# MORGANTOWN PLANNING COMMISSION

## **STAFF REPORT**

**CASE NO:** S16-01-III / Seneca Village, LLC / 709 Beechurst Avenue

# PLANNING AND ZONING CODE CONFORMITY REPORT

SHEET No.  
**C4.00**

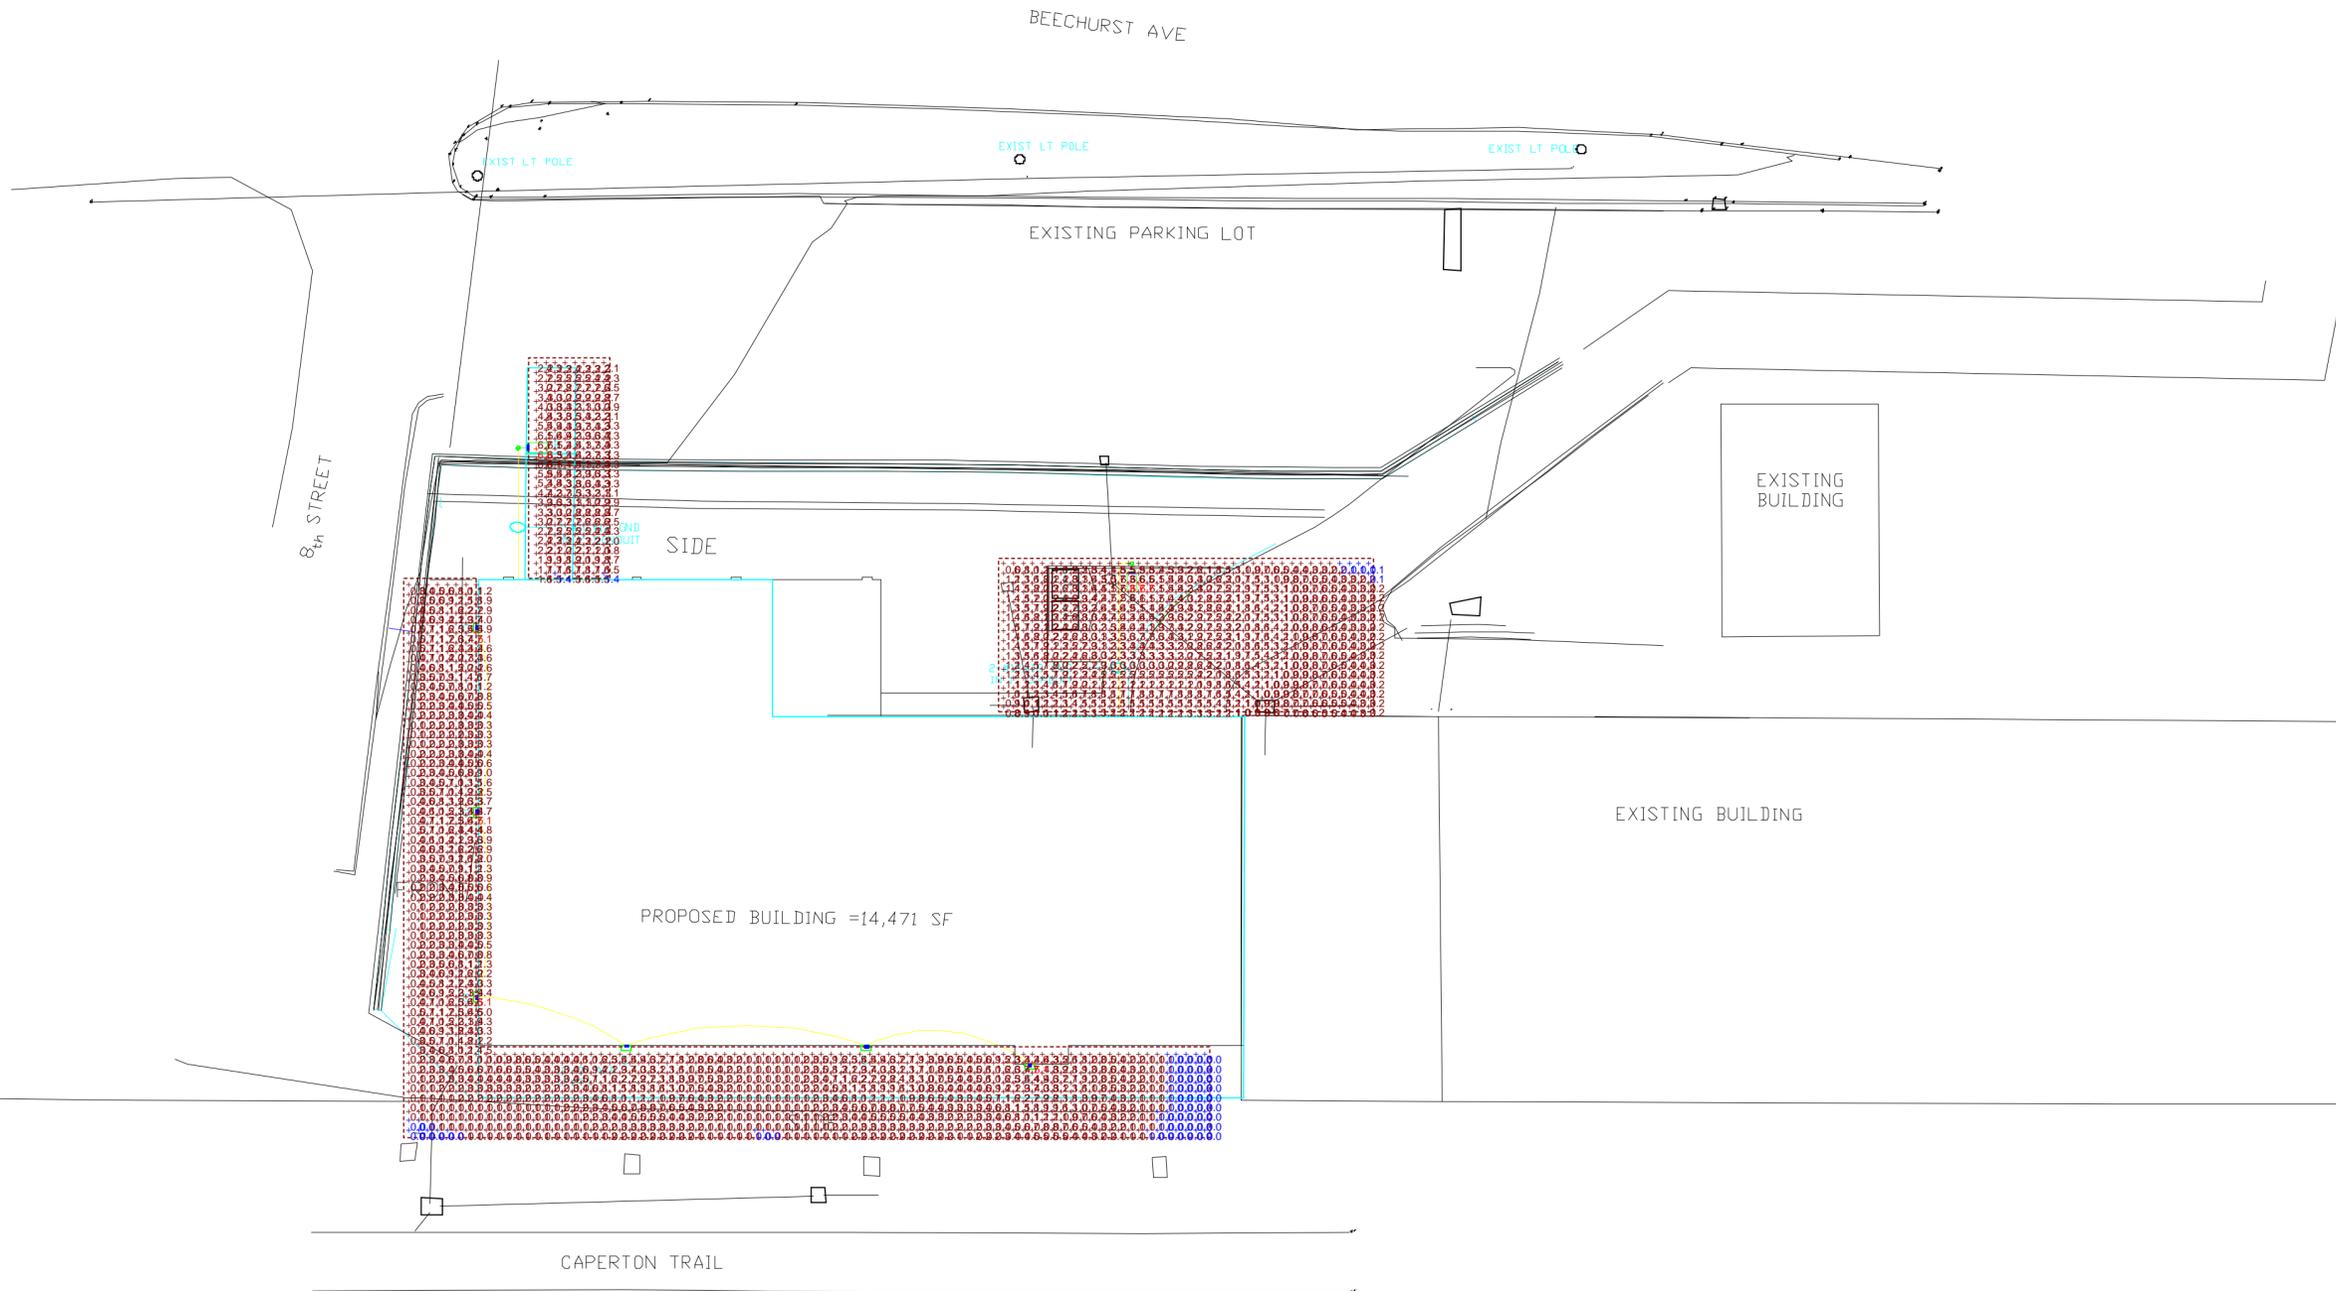
TBD	<i>A preliminary Landscaping Plan is provided on Sheet C4.00. Conformity with landscaping requirements will be completed at building permit application.</i>
-----	--

SENECA VILLAGE SITE LIGHTING

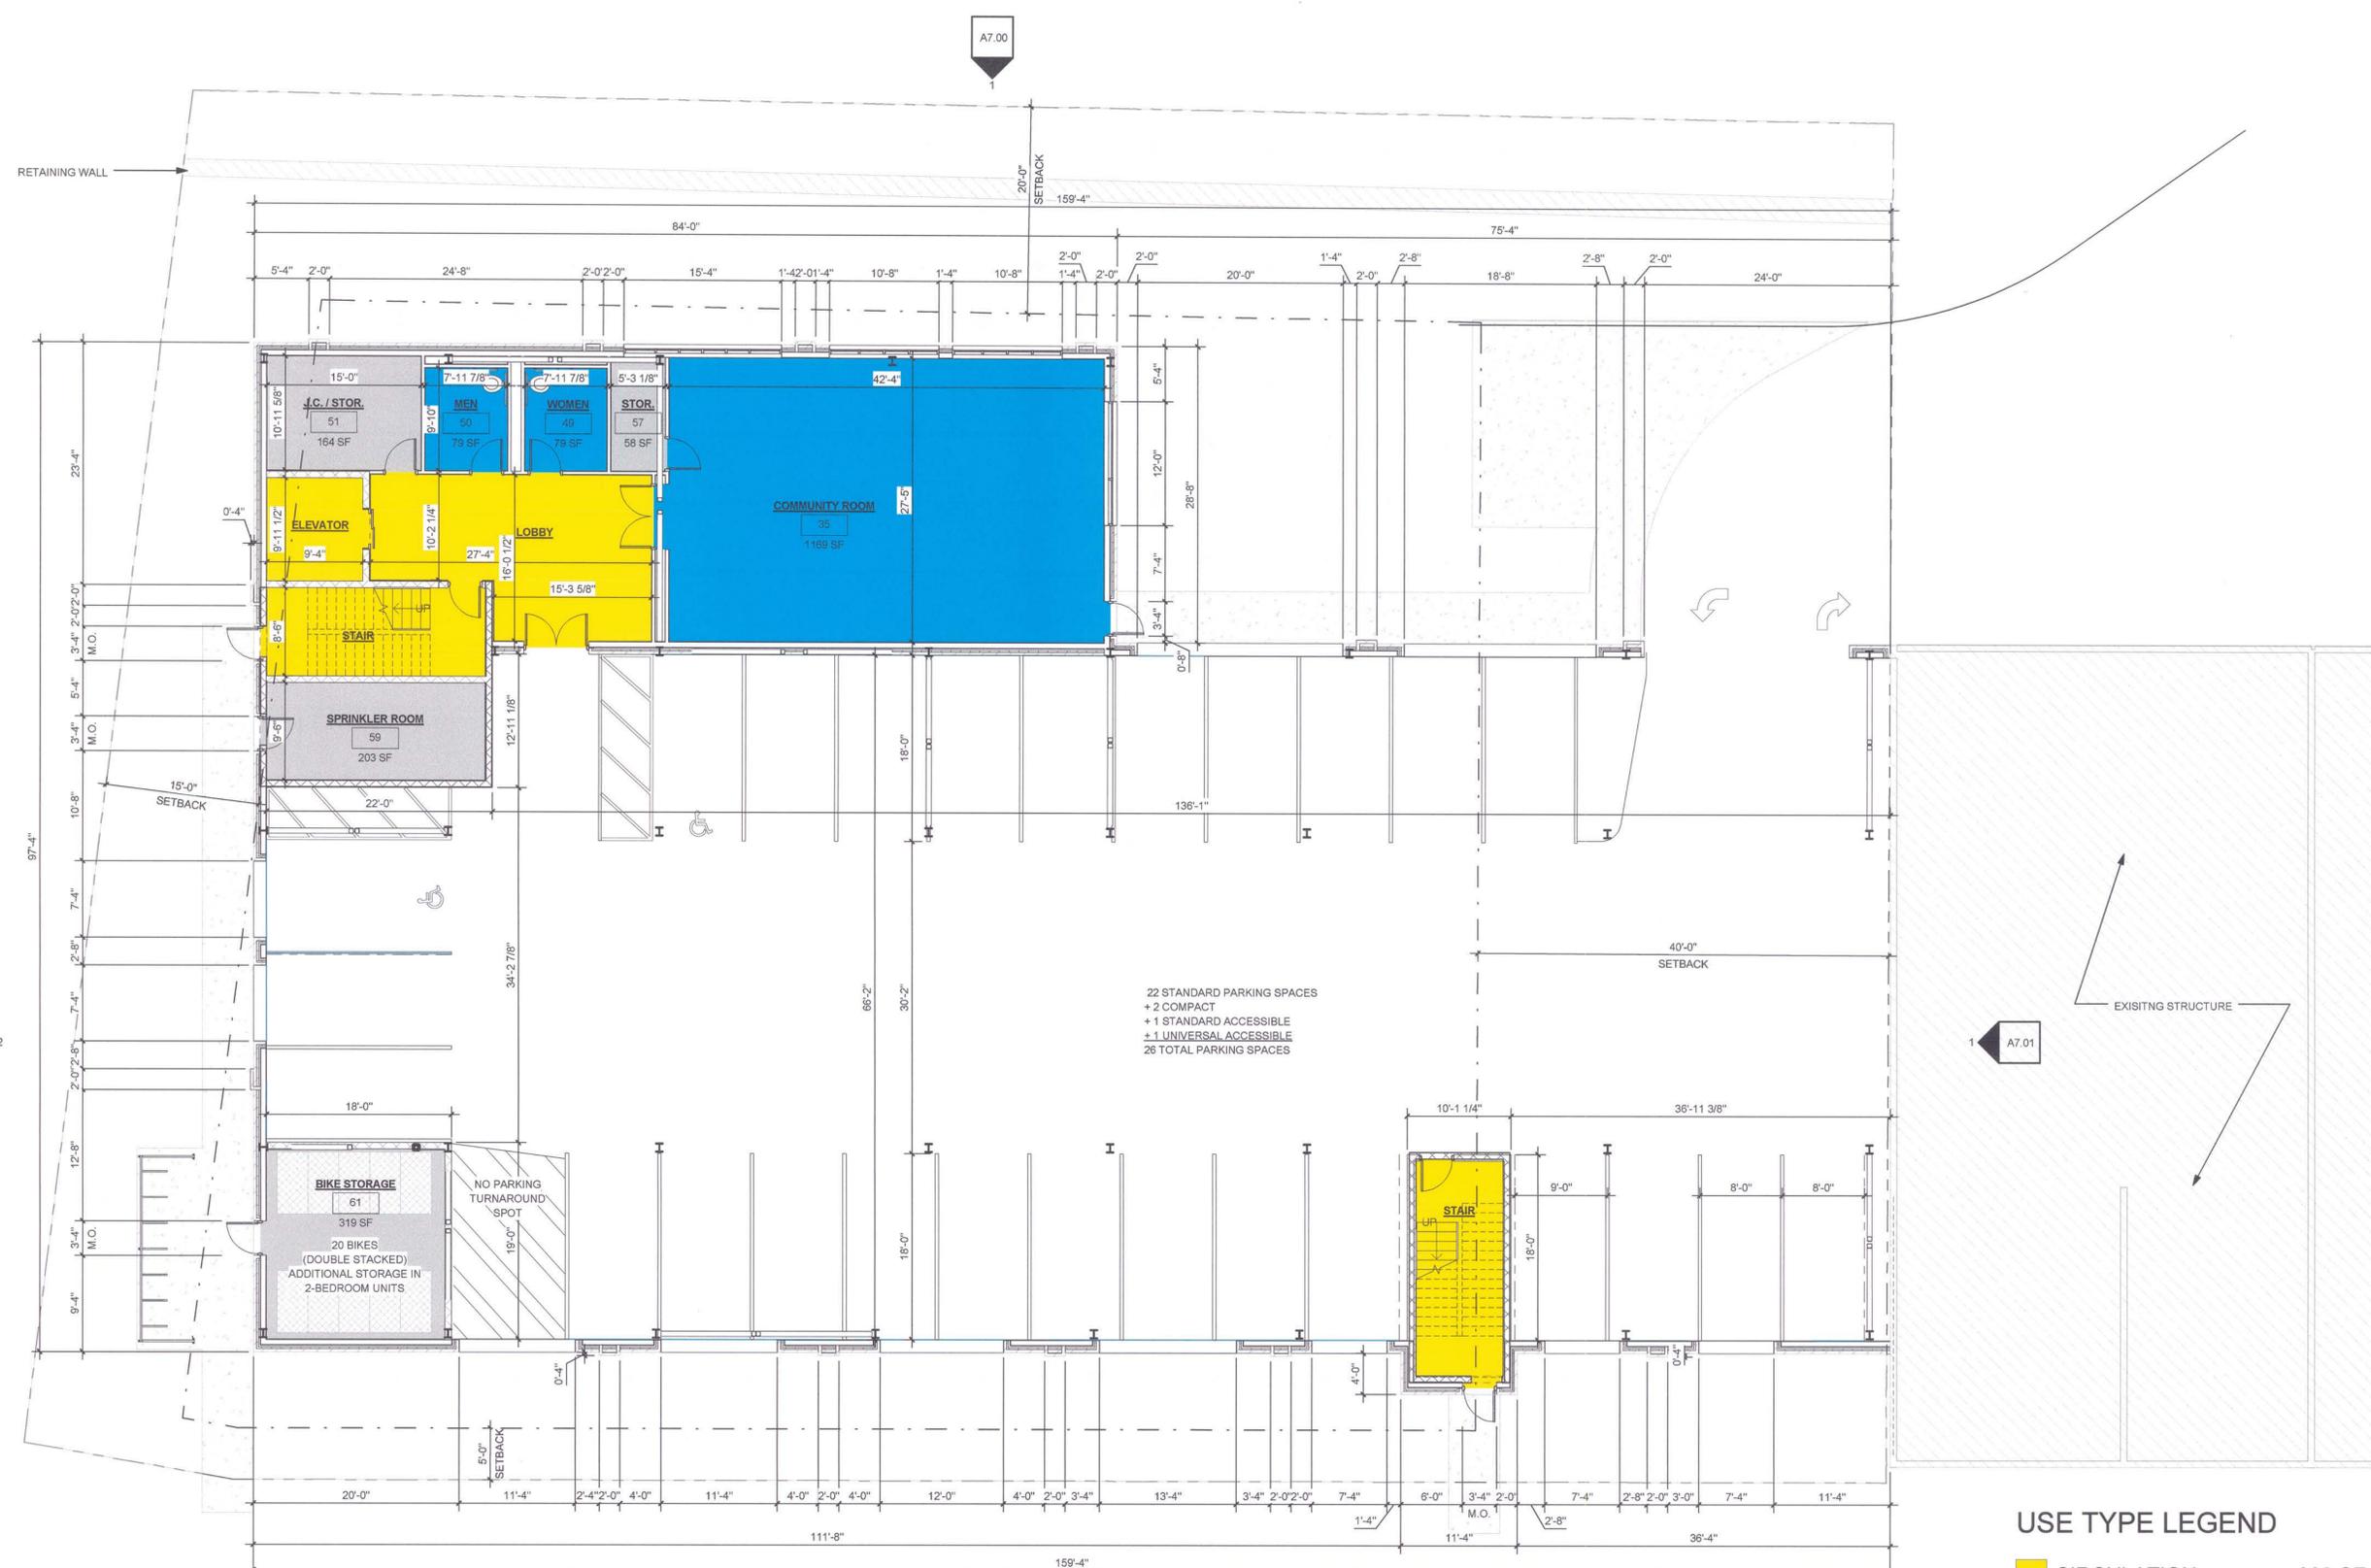
<i>The preliminary Lighting Plan provided on Drawing No. 1 prepared by “Visual” requires modifications to improve legibility. Conformity with lighting requirements will be determined a building permit application.</i>
